## **Pilot Region-Based Optimization Program for Fund-Lead Sites in EPA Region 3**

### **Site Optimization Tracker: Hellertown Manufacturing Hellertown, Pennsylvania**

EPA 542-R-06-006e  
December 2006  
[www.epa.gov](http://www.epa.gov)

Report of the Remediation System Evaluation,  
Site Visit Conducted at the Hellertown Manufacturing Superfund Site  
June 5, 2001

## Capture Zone Width Calculation, One Extraction Well

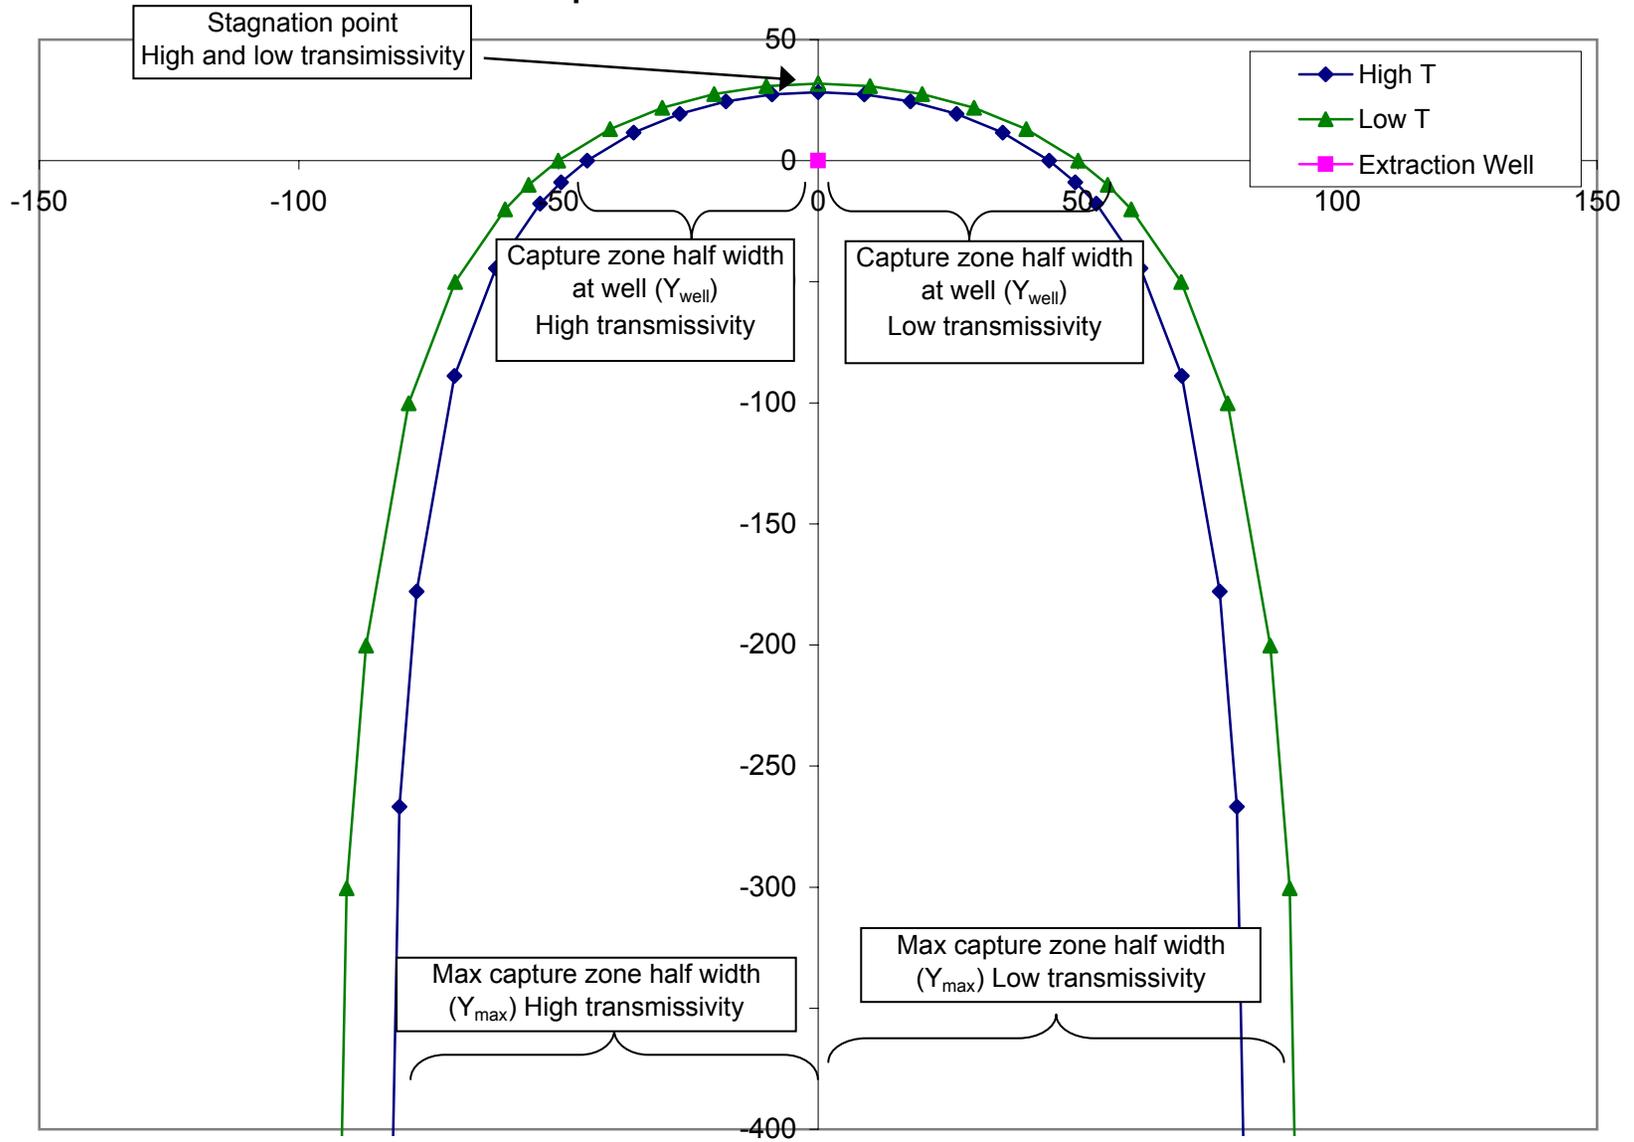
2. When installing the new wells downgradient of the extraction well, the wells should be placed beyond the stagnation point of the capture zone. The calculations in Appendix A suggest a range of likely locations for the stagnation point when pumping at 135 gpm, assuming the aquifer is 200 feet deep, there is a hydraulic gradient of 0.03 feet per foot, and the transmissivity ranges from approximately 4,300 to 4900 ft<sup>2</sup> per day (high and low estimates from site documents). The calculations suggest that the stagnation point is at 28 to 32 feet downgradient of the extraction well. The transmissivity could easily fall outside of the above-mentioned range. To be conservative, it is suggested that the site team place the proposed monitoring wells at least 100 feet downgradient of the extraction well. Based on site maps and discussions during the followup meeting on 12/16/04, the proposed locations indicated are much further downgradient and should be sufficiently conservative to avoid installing the new monitoring wells within the capture zone.

The spreadsheet and chart on the following pages calculates the estimated distance between the extraction well and the capture zone stagnation point.

Capture Zone Width Calculation Results (Low T)			
Input Parameters		Output Parameters	
Transmissivity T (ft <sup>2</sup> /day)	4325	Stagnation Distance X <sub>0</sub> (ft)	-31.88
Pumping Rate Q (gpm)	135	Max Capture Half Width Y <sub>max</sub> (ft)	100.14
Pumping Rate Q (ft <sup>3</sup> /day)	25,900	Capture Half Width at Well Y <sub>well</sub> (ft)	50.07
Hydraulic Gradient i (ft/ft)	0.03

Capture Zone Width Calculation Results (High T)			
Input Parameters		Output Parameters	
Transmissivity T (ft <sup>2</sup> /day)	4871	Stagnation Distance X <sub>0</sub> (ft)	-28.30
Pumping Rate Q (gpm)	135	Max Capture Half Width Y <sub>max</sub> (ft)	88.92
Pumping Rate Q (ft <sup>3</sup> /day)	25,900	Capture Half Width at Well Y <sub>well</sub> (ft)	44.46
Hydraulic Gradient i (ft/ft)	0.03

**FIGURE 1-1. SITE LAYOUT SHOWING THE LOCATIONS OF THE MONITORING WELLS AND THE EXTRACTION WELL.**

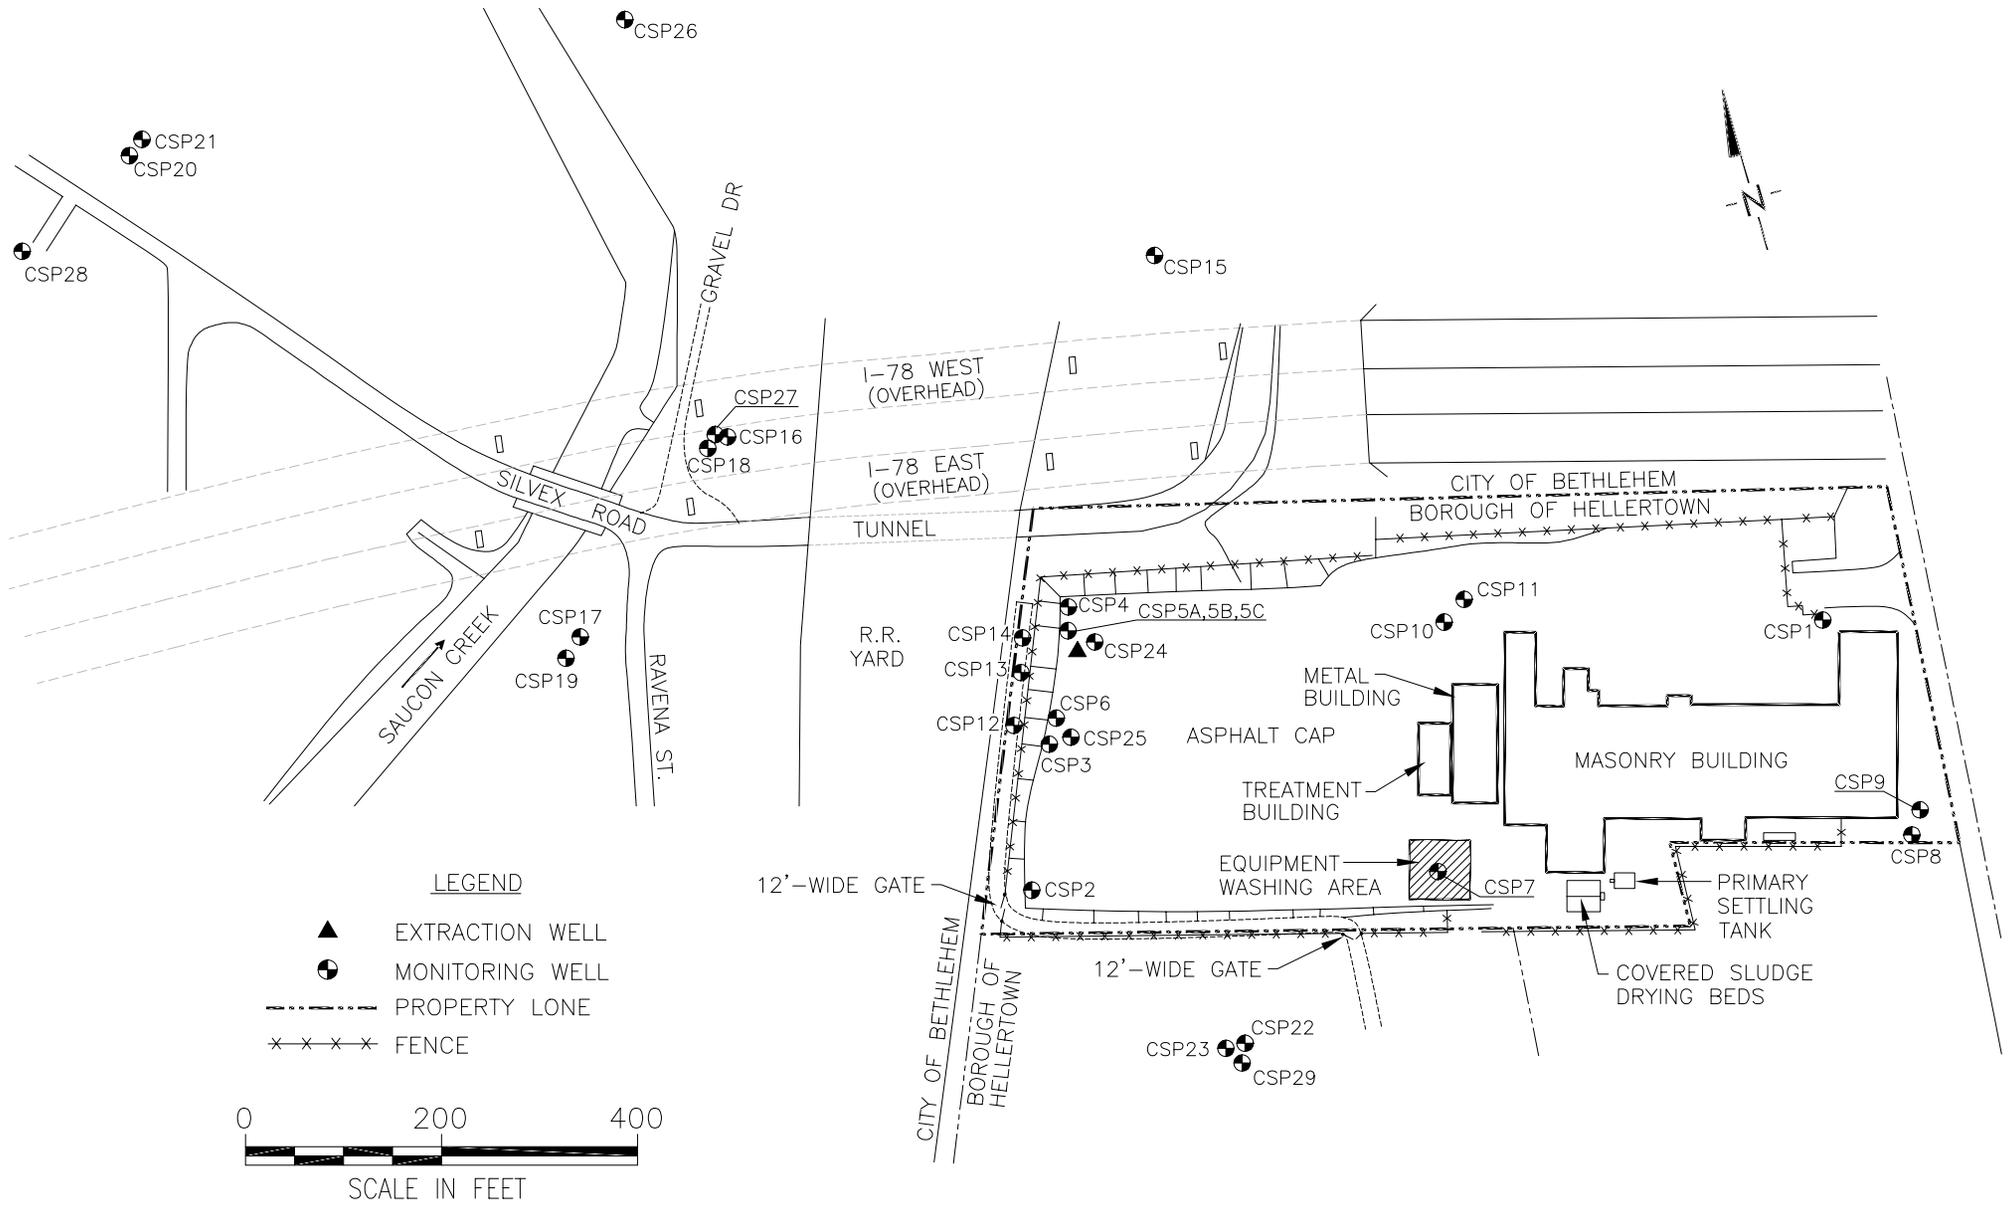
The November 2000 water levels provide sufficient information from the shallow bedrock wells to suggest that ground water in the shallow bedrock near wells CSP-12, CSP-13, CSP-14, and CSP-5A is captured by the extraction well. Data is too sparse to estimate ground water directions and capture in the overburden and the deep bedrock or in the shallow bedrock further from the extraction well. Because no monitoring wells or water-level measurements exist for over 400 feet to the west (downgradient) the extent of contamination and capture is unknown downgradient of CSP-12, CSP-13, CSP-14, and CSP-5A.

Ideally, one or more monitoring wells in the shallow bedrock should be added between CSP-14 and Saucon Creek, to allow increased resolution for water level evaluation as well as water quality evaluation. The ability to add one or more wells in that area may be hampered by access issues, as well as limitations due to steep slopes immediately west of CSP-14. To add one well should cost approximately \$20,000 in capital costs, and additional sampling and analysis of that well will be less than \$2,000 per year.
